ADMINISTRATIVE DECISION – MINOR HISTORIC REVIEW

MINOR HISTORIC REVIEW CASE NO. HIS15-31

APPLICATION NO: 15-113960-DR

REQUEST: Minor historic design review of a proposal to replace the electrical box with associated equipment, replace the existing primary sign, and install a new “No Trespassing” sign at the Temple Beth Sholom, a Salem Local Landmark, constructed in 1947, on property approximately 0.28 acres in size, and located at 1795 Broadway Street NE (Marion County Assessor’s Map and Tax Lot number: 073W14CC-016000).

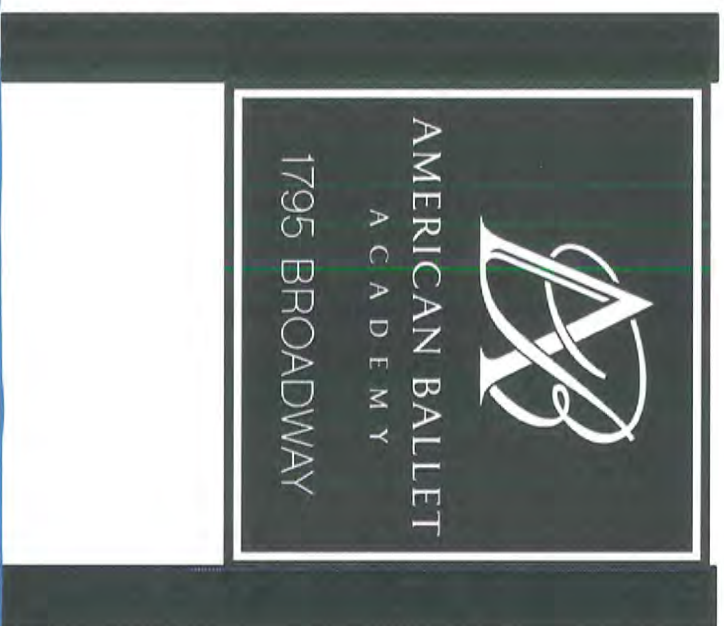
Finding: The applicant is proposing to replace the face of the existing historic primary sign for the building, reusing the historic posts, thereby meeting SRC 230.05b(c)(1) for this portion of the proposal.

Finding: The proposed primary sign is constructed of wood (red cedar), and the proposed "No Trespassing" sign is constructed of aluminum (metal), thereby meeting SRC 230.056(c)(7).

Finding: The proposed primary sign is 36" x 36" in size, of red cedar, and will be located in front of the building within the historic sign posts, with light letters on a dark background which is compatible in size and scale with the resource thereby meeting SRC 230.056(c)(15) for this portion of the proposal.
